SERVICETEKNOTES

TABLE OF CONTENTS

WFM300, CRT INTERNAL GRATICULE CHANGE

WFM300 OSCILLATION DISTORTING TRAILING EDGE OF SYNC PULSE

Figure 2

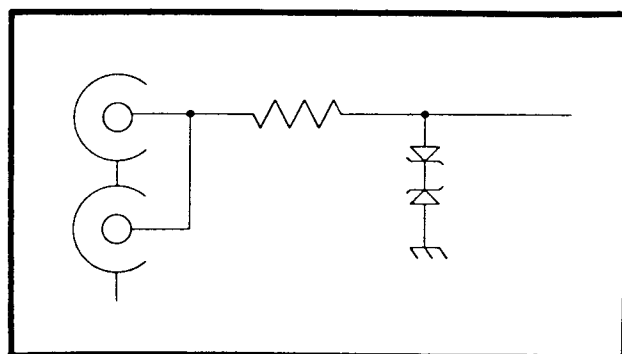
Mod 62317 makes the changes necessary to insure that the 118F02 Video Interface Board will accurately calculate channel delay. The changes shift the gain determination node such that the 118AS input op amps are less sensitive to circuit crosstalk noise.

- A7R222, A7R223, A7R122 and A7R123 are changed from 21.1K ohms to 4.53K ohms, P/N 321-0256-00.
- A7CR118, A7CR119, A7CR125, A7CR126, A7CR218, A7CR219, A7CR225 and A7CR226 are removed. In their place, two zener diodes are teepee'd into the circuit, in a back-to-back configuration, on each of the four input lines. Figure 1 (below) illustrates the circuit before the changes. Figure 2 illustrates the circuit after the changes. The new diodes are P/N 152-0688-00.

- A6R230, A6R235, A6R331 and A6R340 are changed from 221 ohms to 16.9K ohms, PN 321-0311-00.

These change details are given for information only. The early circuit configuration or the later one will work equally well when the 118AS is used in a system that uses the 110S as the controlling device. This mod is only necessary with the addition of the 118F02, due to its use of video signals for delay computation. 118F02 Field Kits contain the required parts and instructions to put these changes into pre-mod instruments.
